Lincoln Property Company Odell School Road Site

For Public Hearing
Petition # 98-46 (C)

Technical Data Sheet

SUBJECT: Administrative Approval for Petition No. 98-46(c) by Lincoln Property Company.

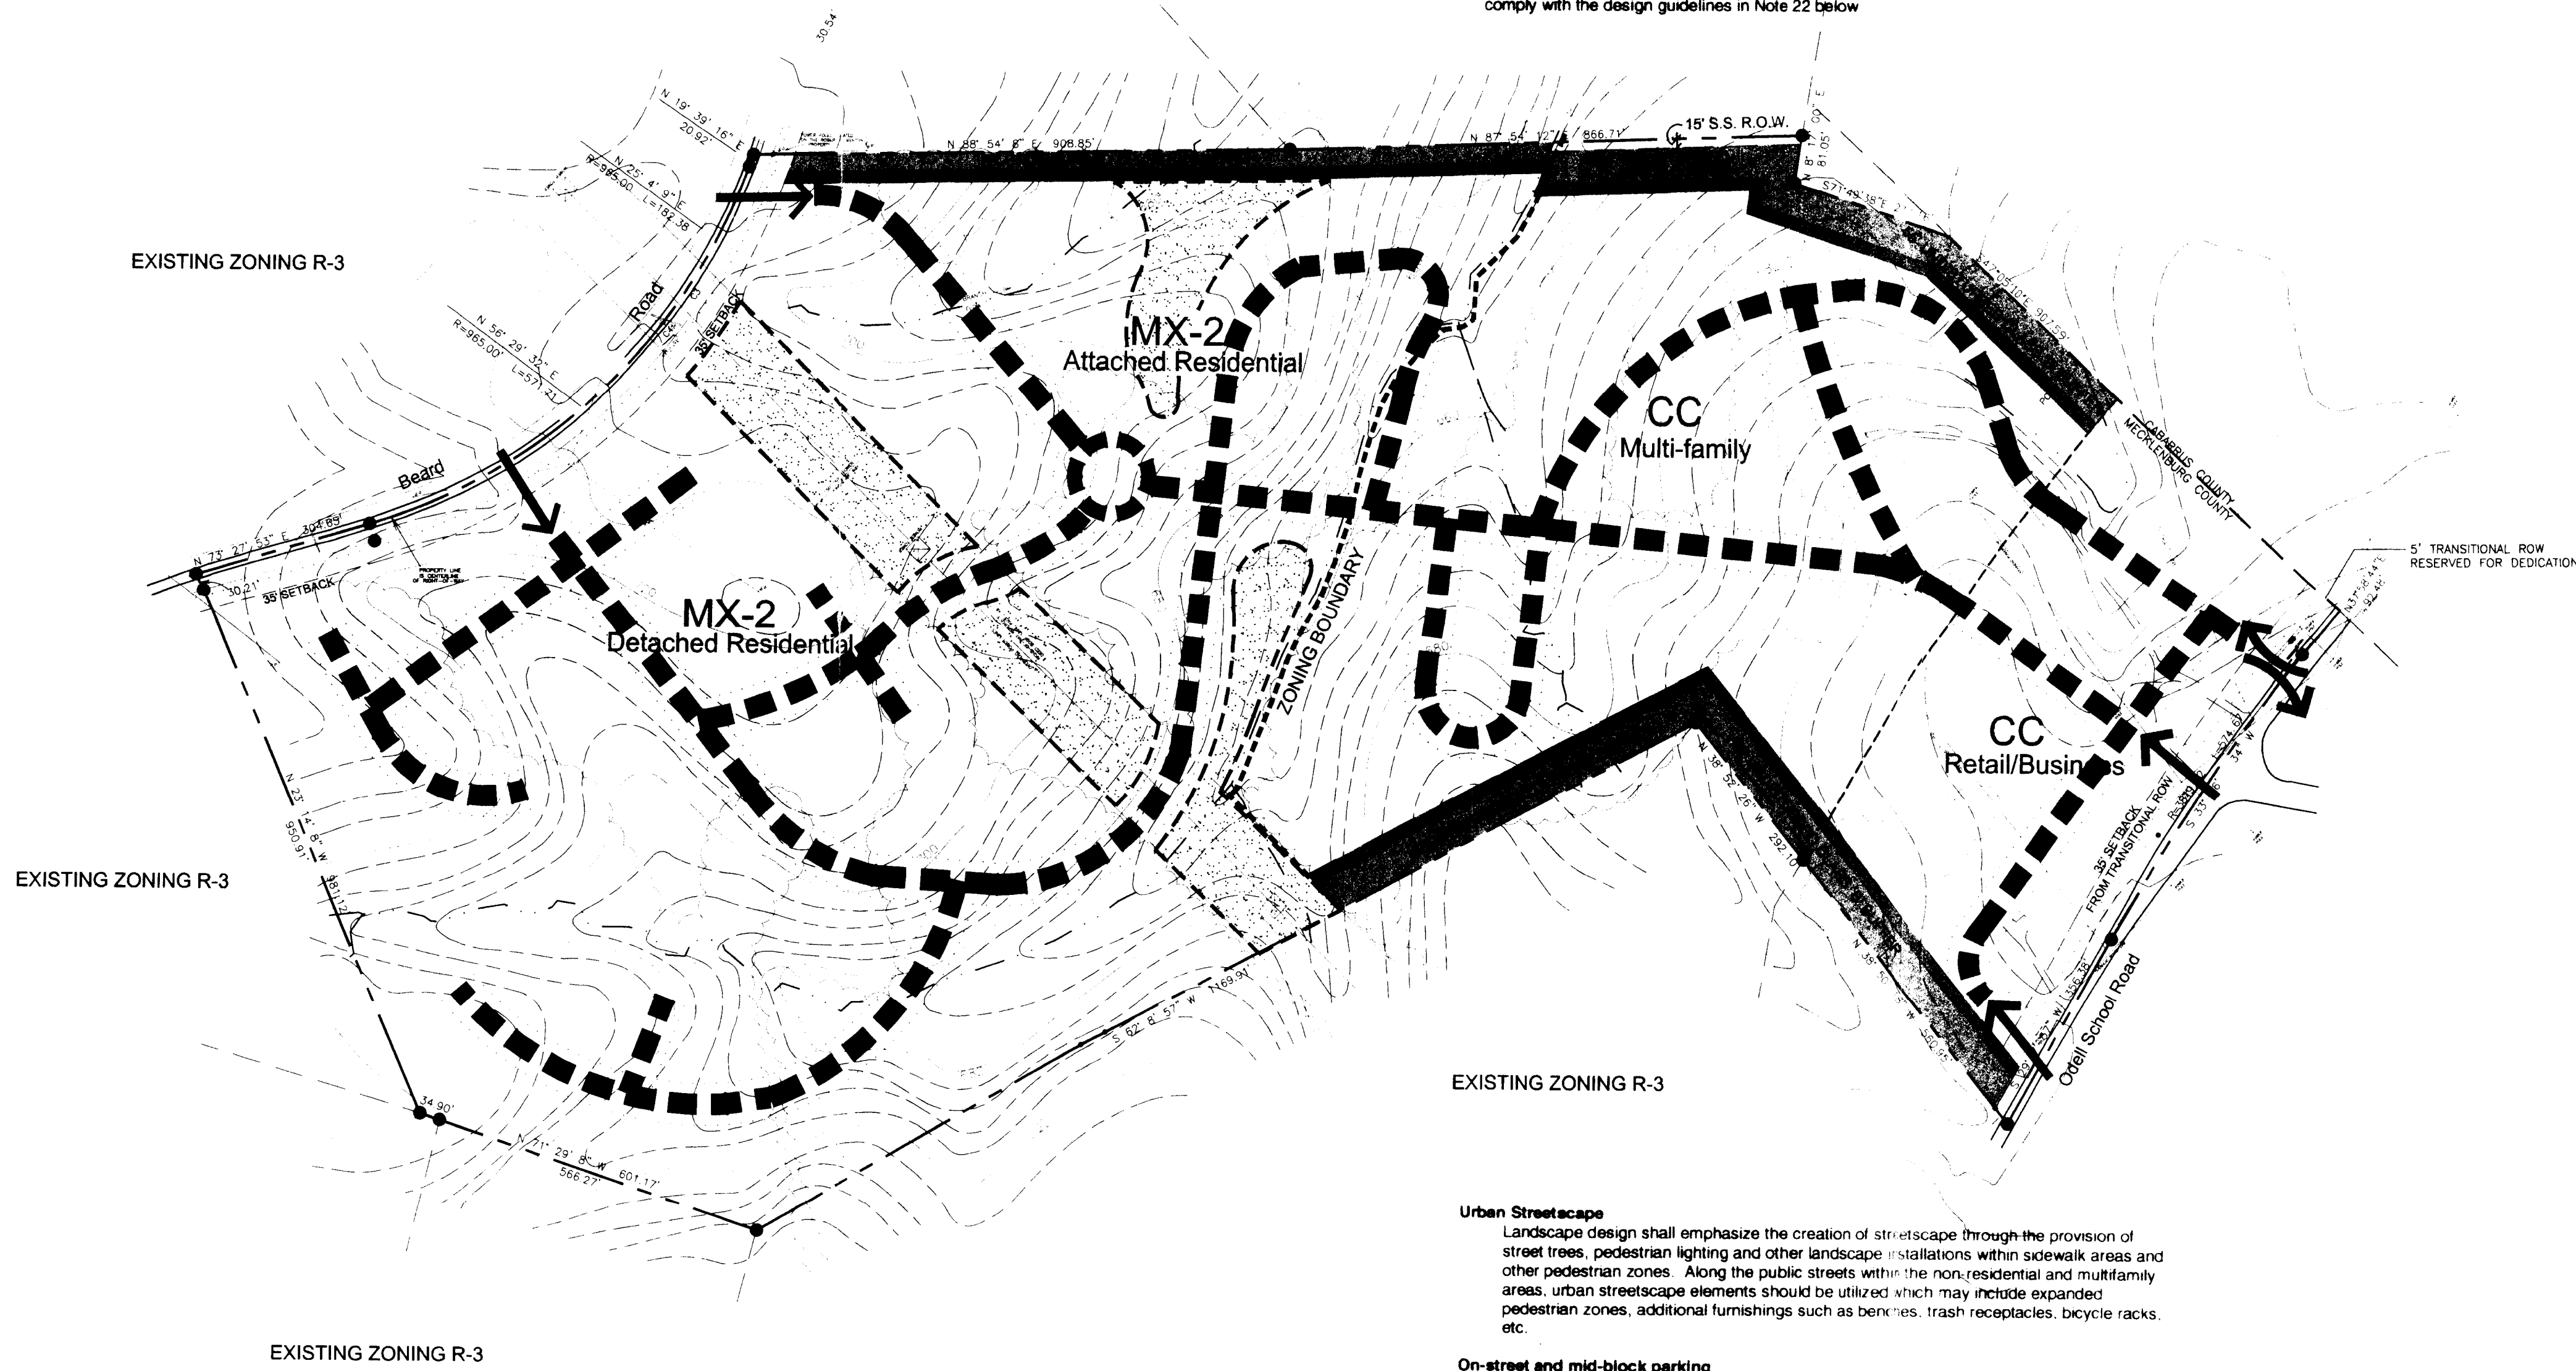
DATE: June 15, 1998
PROJECT NO: 18005
REVISIONS:
Sept. 18, 1998: Revised per Planning Commission review.
October 30, 1998: Revised per Planning Commission review.
June 11, 1999: Revised Buffer for 15' S.S. R.O.W.
